ADDENDUM NO. 03
December 19, 2025

To Drawings and Specifications dated December 05, 2025.

PKG 3B – GPHS ATHLETICS, ACADEMIC & MULTI-PURPOSE FACILITY

Prepared by: PBK
11 Greenway Plaza, 22nd Floor
Houston, TX 77046-1104
PBK Project No: 240539

01 LEVEL 1 - AREA F NEW MULTIPURPOSE FACILITY FLOOR PLAN
1/8" = 1'-0"

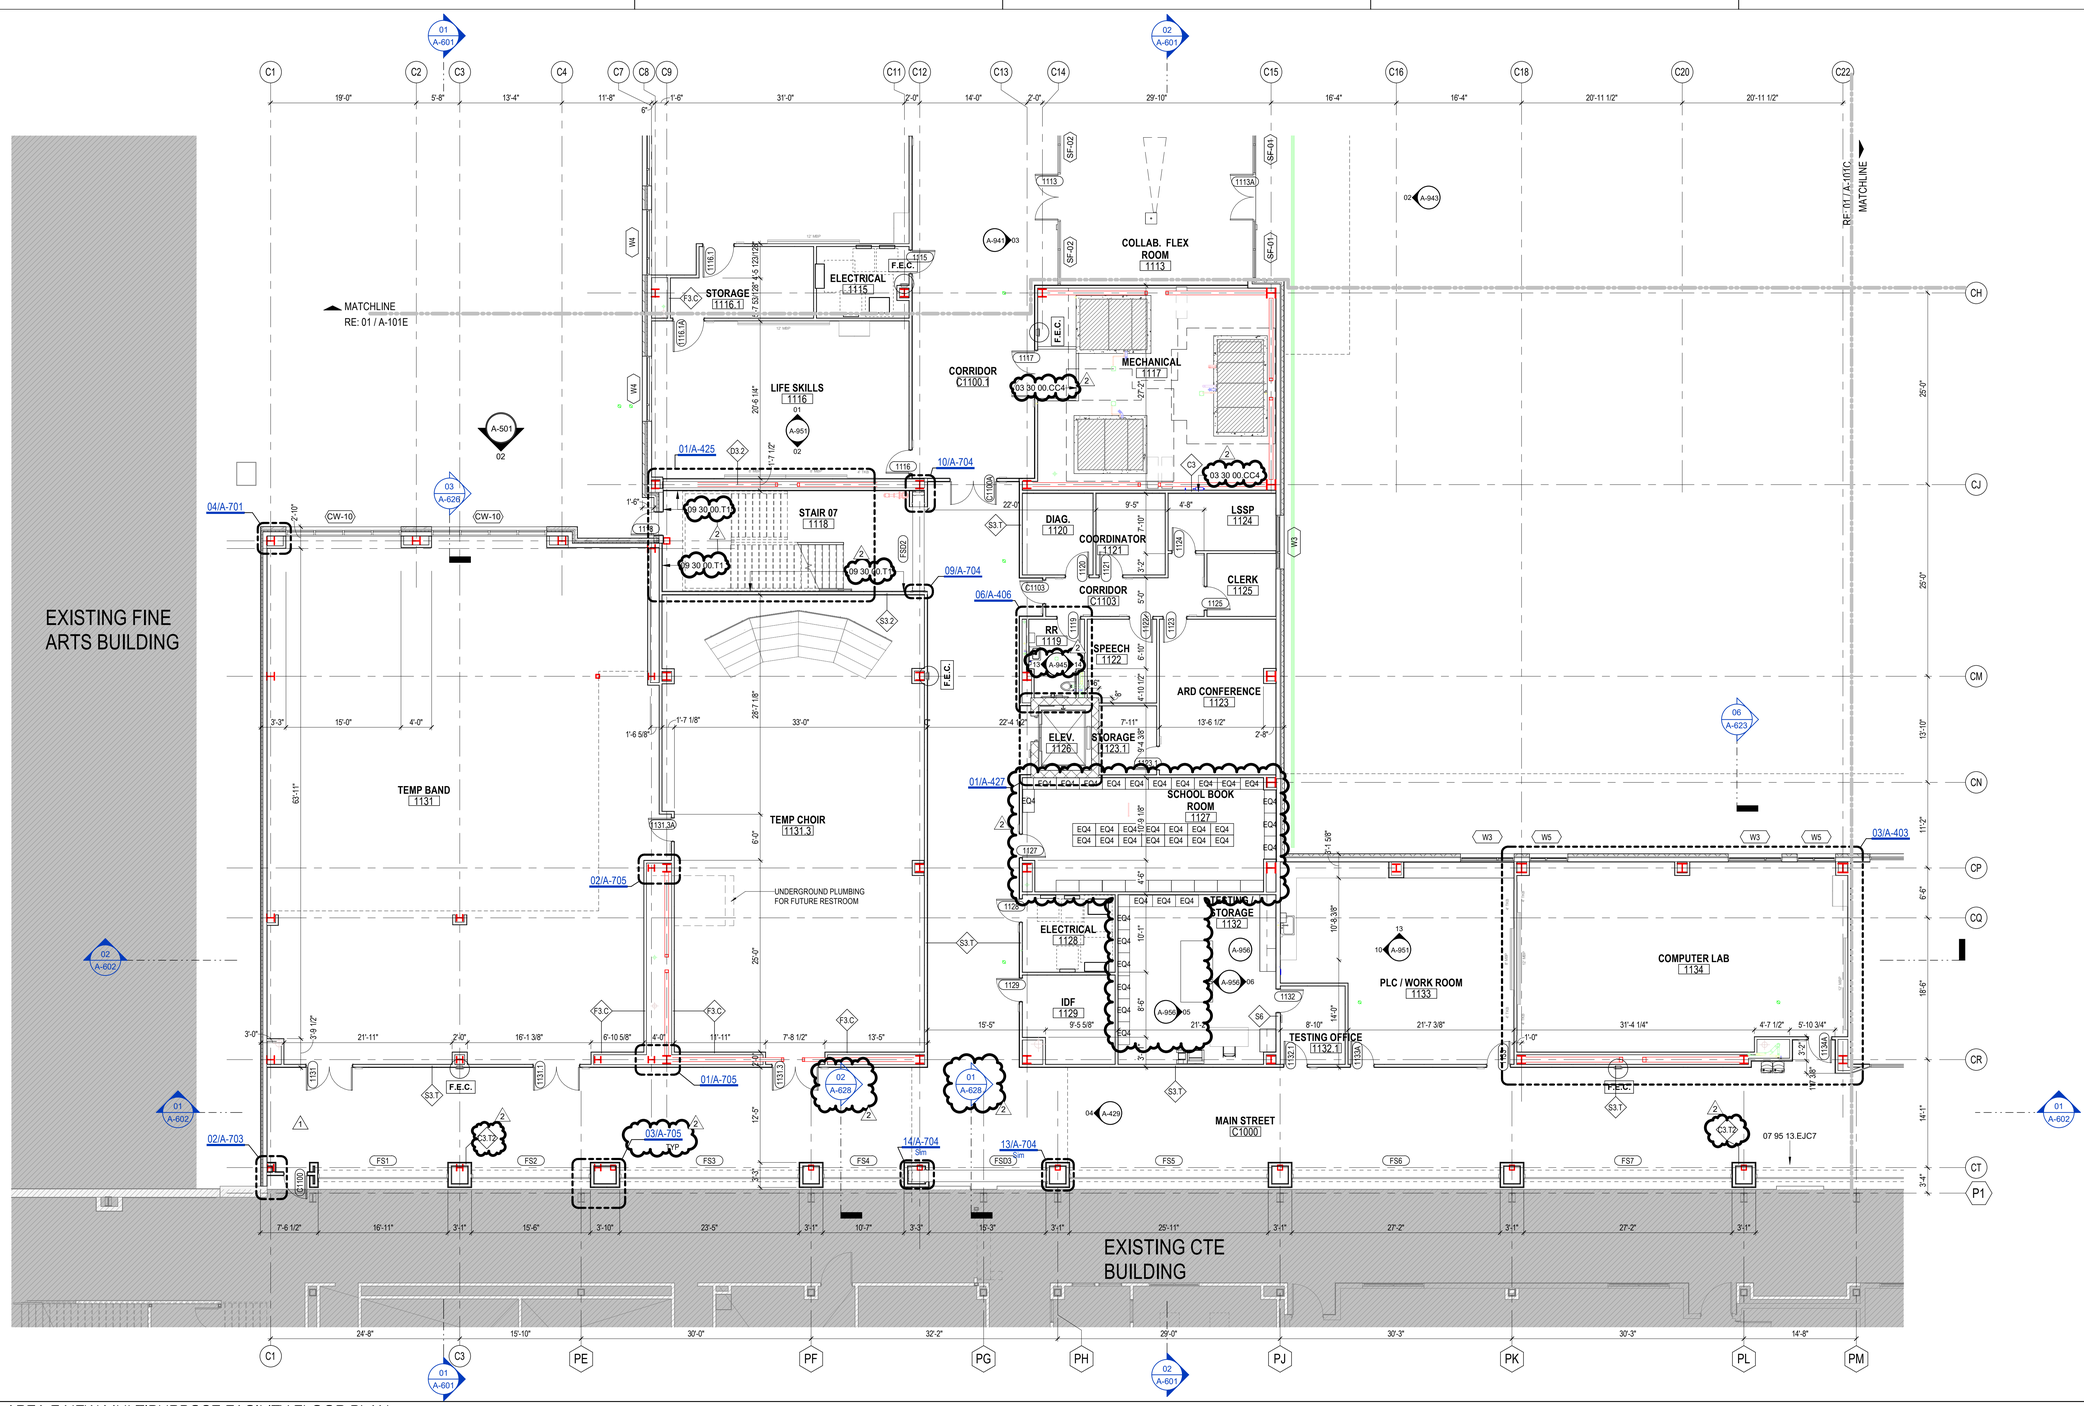
Question 04: Several rooms on A101F and A103F that also appear to have shelving. None of them are marked so that may be some other type of equipment. Please clarify these are CFCI metal shelving and what type.

i. Response: Equipment schedule has been added to sheet to show type, count, model, etc. these are CFCI. They have been tagged in plan.

01 LEVEL 1 - AREA C NEW MULTIPURPOSE FACILITY CEILING PLAN
1/8" = 1'-0"

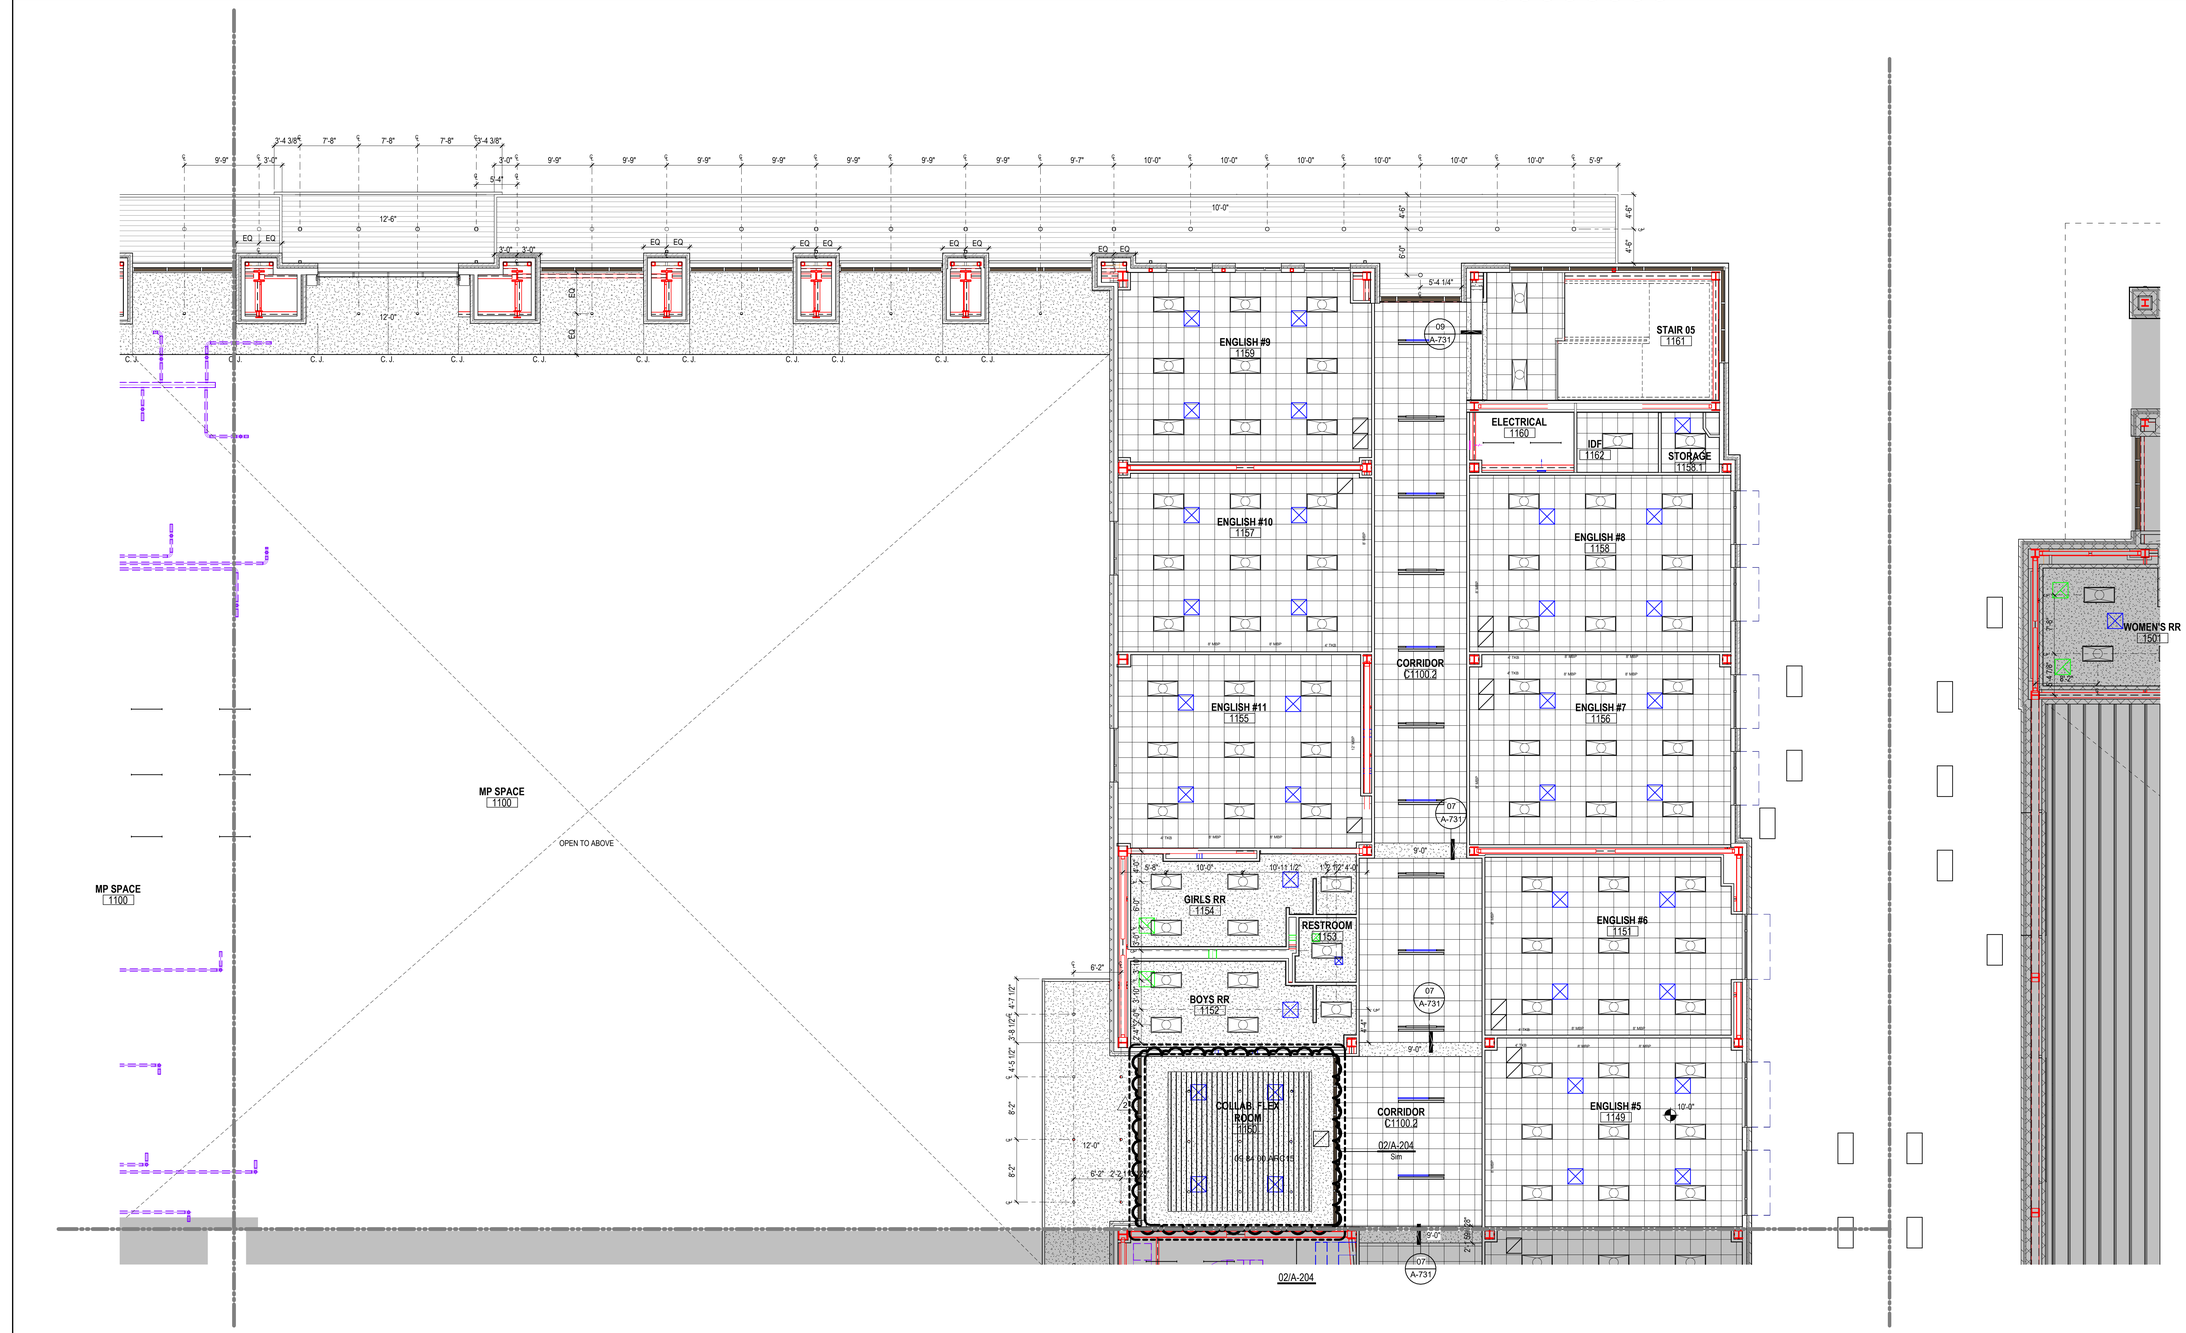
Question 17: Sheet A201C. What ceiling is in room 1150 and 1113 Collab Flex Room, there is nothing matching in the legend for what it is?

i. Response: Sheets A-201C and A-201E have been updated with the correct ceiling type. The baffle has been added to the ceiling fixture legend.

LEVEL 2 - AREA C CEILING PLAN
A-202C
FOR BLUEBEAM LABELING/OCR:

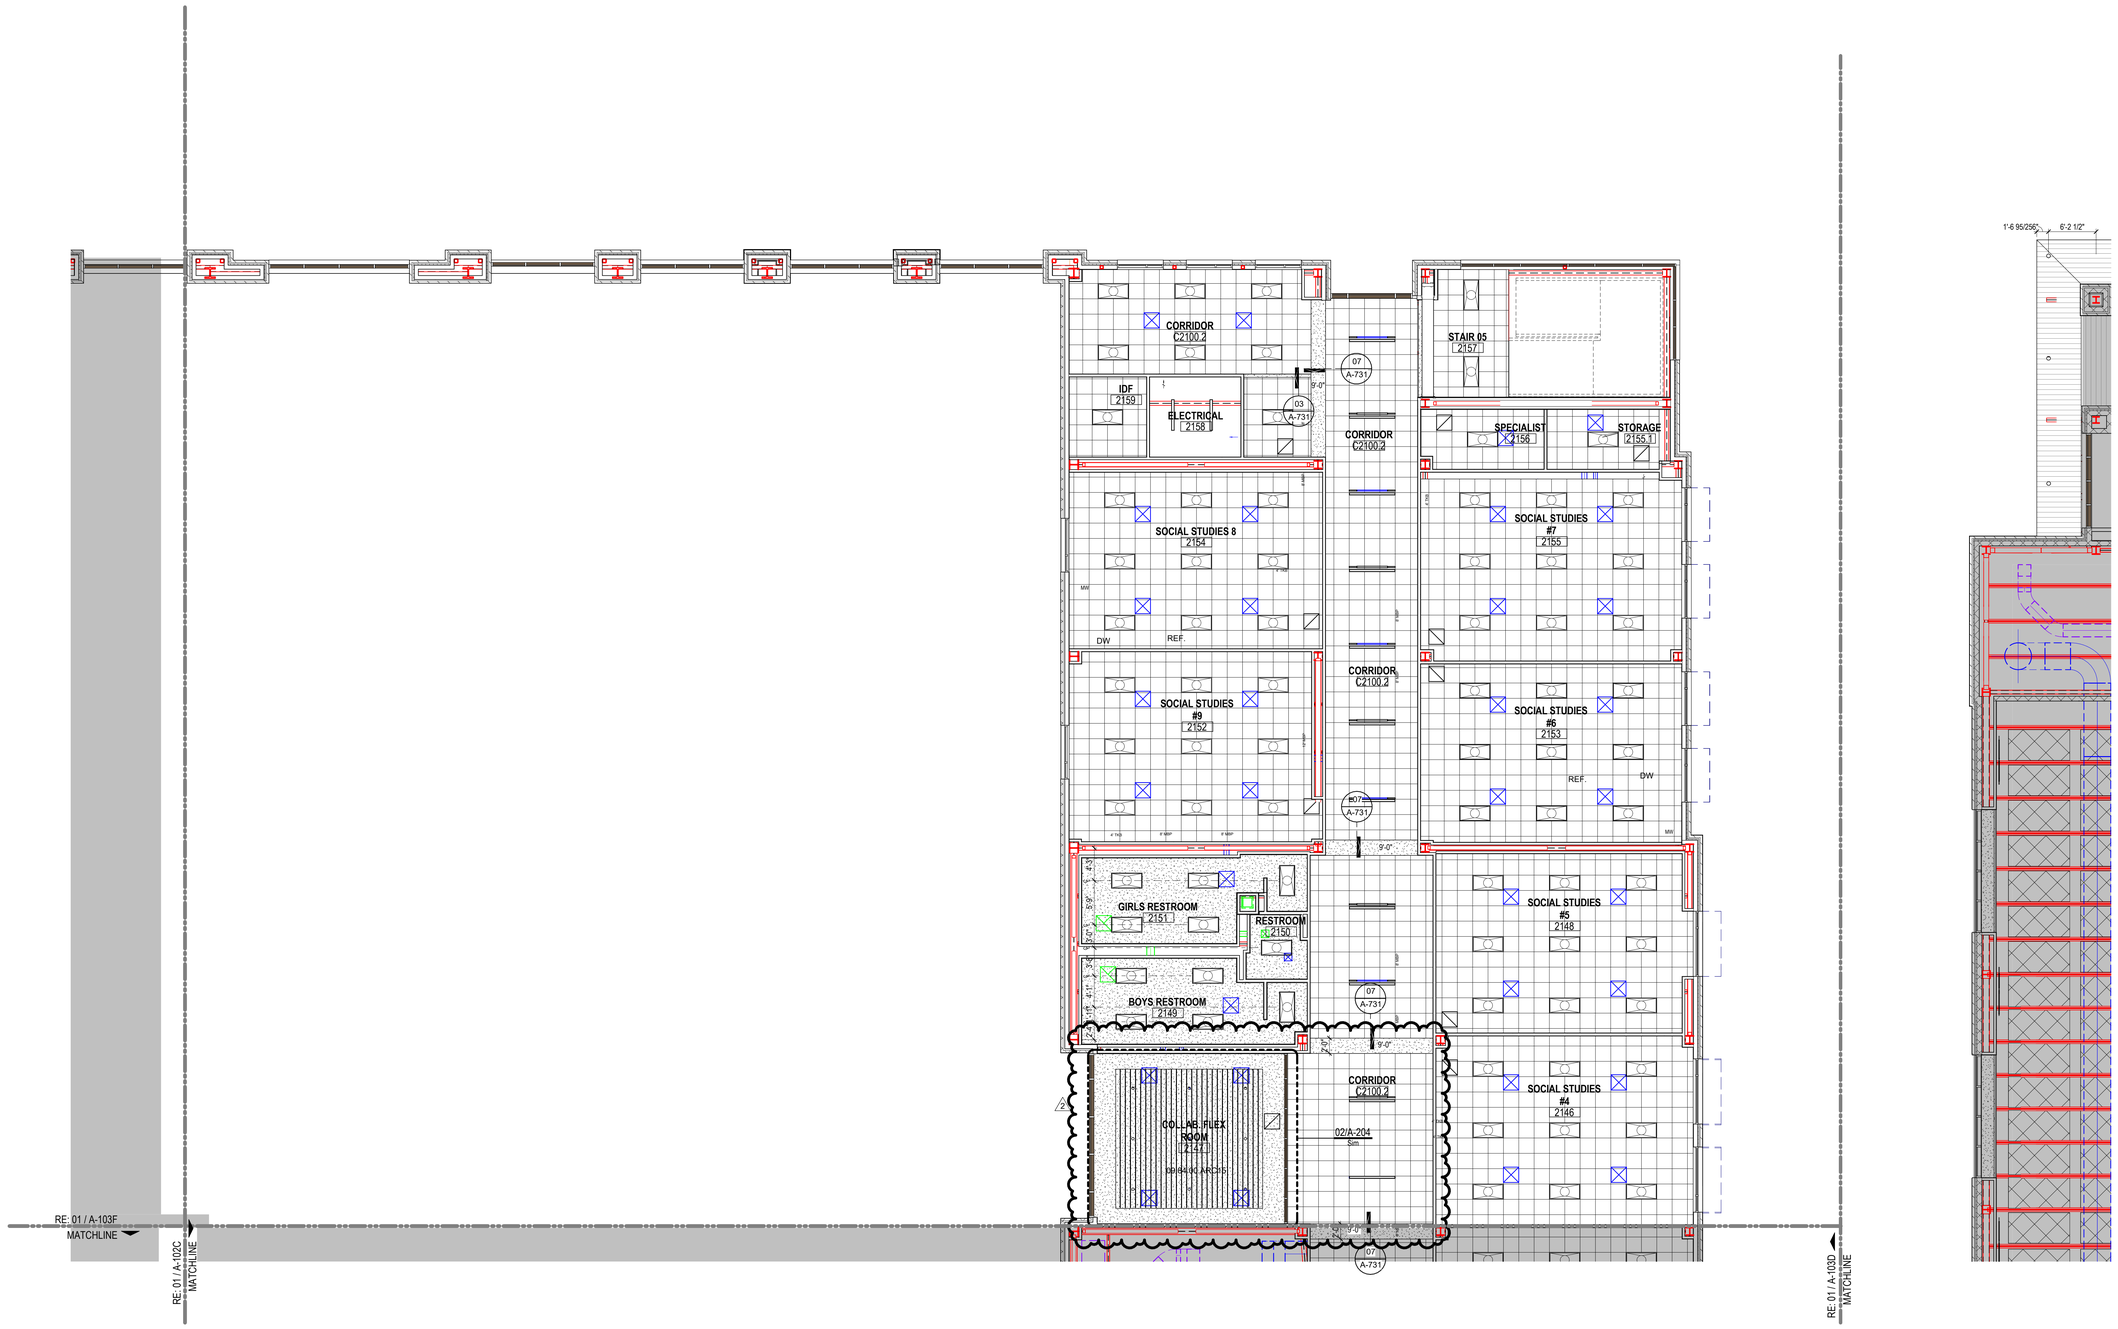
Question 08: According to the finish schedule on A-900, the ARC15 panels are supposed to be in the Collab/Flex Rooms. The RCPs for these rooms do not show baffles. Also, the RCPs for the Collab/Flex Rooms on floor 1 are hatched differently than the ones on floors 2 & 3. Please clarify.

i. Response: The Collab. Flex Rooms shown on sheets A-201C, A-201E, A-202C, A-202E, A-203C, and A-203E have been updated to include baffles. All associated RCPs have also been revised to reflect a consistent RCP across floors. Updated on ADD 3
